4 December 2015

TG584-01F04 (r2) RE NV Response to submissions

Riverstone East Precinct Noise Assessment - Response to Submissions

Figure 3: Potentially affected residential lots [Base map from exhibited ILP]

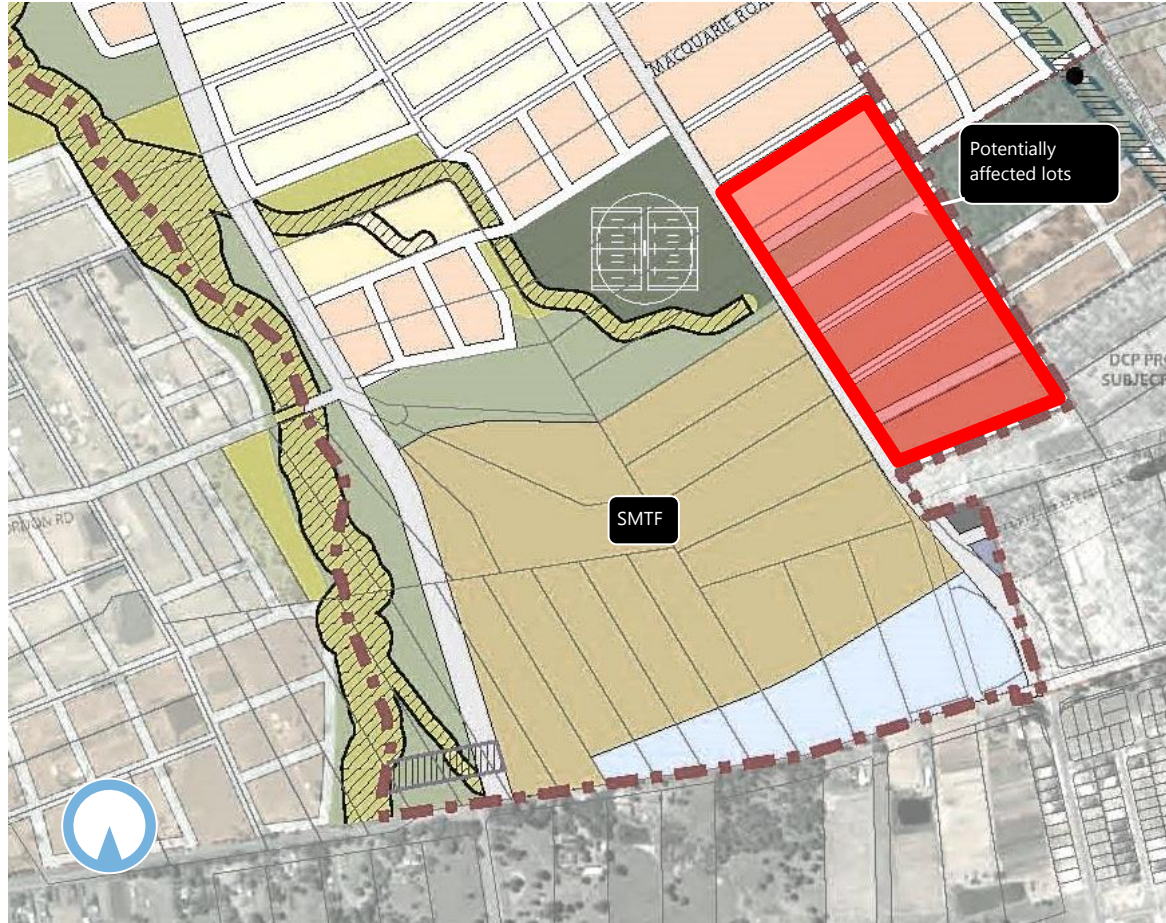
In their submission, Transport for NSW (TfNSW) requested that appropriate planning controls be provided for the residential land adjacent to the SMTF to mitigate the impact of noise from the facility.

As outlined above, the future noise emission from the SMTF is currently unknown. While the Planning Approval for the SMTF requires that all reasonable and feasible noise mitigation measures be adopted in the design of the SMTF, and assessment includes current residential uses surrounding the facility, this does not guarantee that compliance at all future noise receptors will be achieved. Furthermore, the operations of the SMTF are proposed to expand beyond that assessed in the EIS with future expansion of the Sydney Metro network.

Future noise emission from the SMTF is likely to be better understood following completion and exhibition of the Operational Noise and Vibration Review (ONVR), which is required to be prepared at completion of the detailed design of the SMTF. As this will occur after finalisation of the Riverstone East Precinct ILP, but before development of potentially affected lots, the following approach is proposed for residential development surrounding the SMTF within the Riverstone East Precinct:

- Identify residential lots that may be impacted by future noise from the SMTF and require that site specific development applications be referred to TfNSW for consultation and approval,
- Developers of identified lots to consult with TfNSW regarding potential future noise impacts from the SMTF. Reference may be made to the ONVR or supplementary information available to TfNSW at the time of application,
- Based on the predicted future noise emission from the SMTF, incorporating any considerations by TfNSW regarding future expansion of SMTF, the developer will be required to assess impacts upon the proposed development and provide any required noise mitigation treatment to the building.
- The noise criteria proposed for the future residential development is discussed below.

The potentially affected lots required to be referred to TfNSW are presented in Figure 3.
